Proposed Erection of New Offices, Residential Units, Hotel and Commercial Units

Address
Waterfront Site 6, Riverside,
Esplanade, Dundee

SUMMARY OF REPORT

Figure 1 – Site Layout

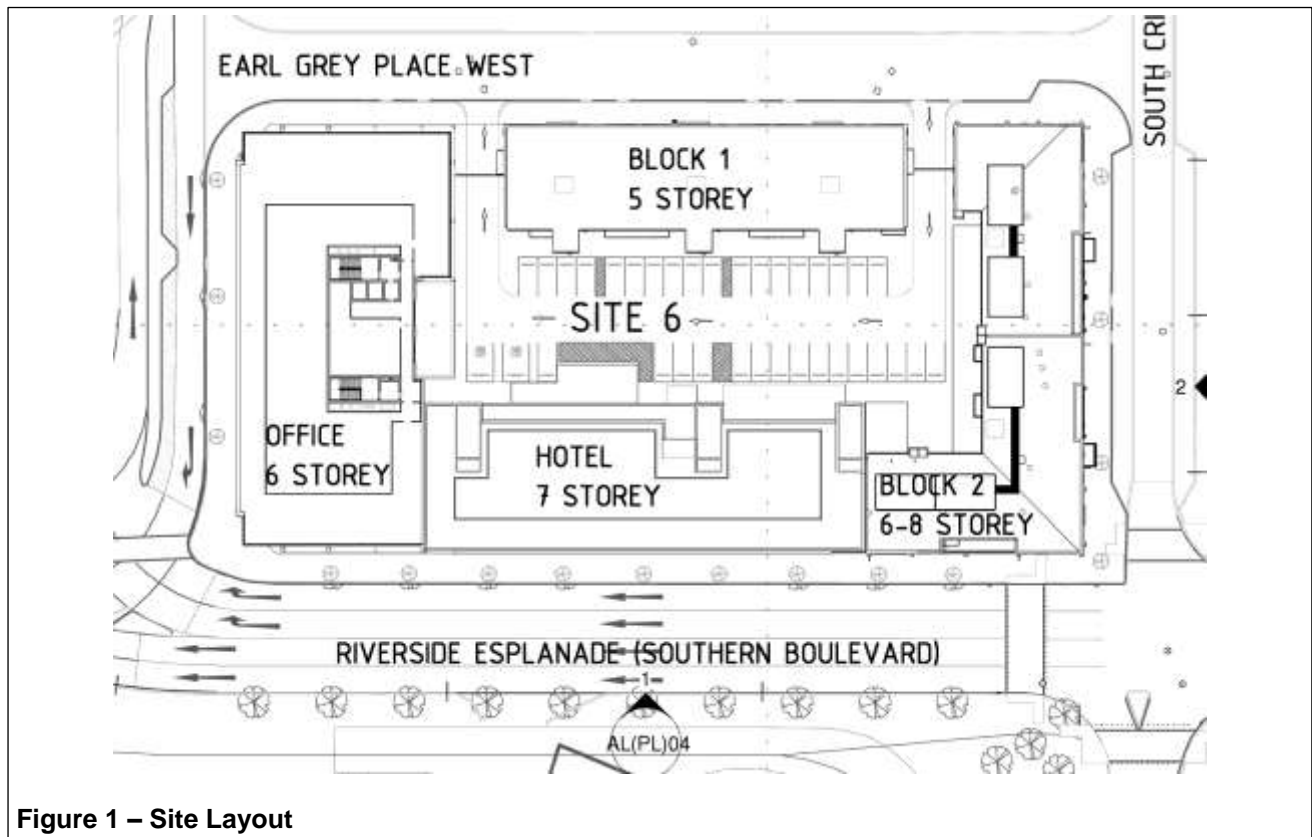
- 1.1 The application proposes the erection of a mixed use development to comprise new offices, residential units, a hotel, retail/commercial units and associated vehicular access and parking spaces.

- 1.2 The development will take the form of four blocks, each containing a mixture of uses. There shall be a central courtyard area to allow for cycle storage access, servicing and some parking. Vehicle access will be taken from Earl Grey Place West and utilise a one way system to control entry/egress. Parking has been provided for the office use and delivery/drop off zones and disabled parking for the hotel use.
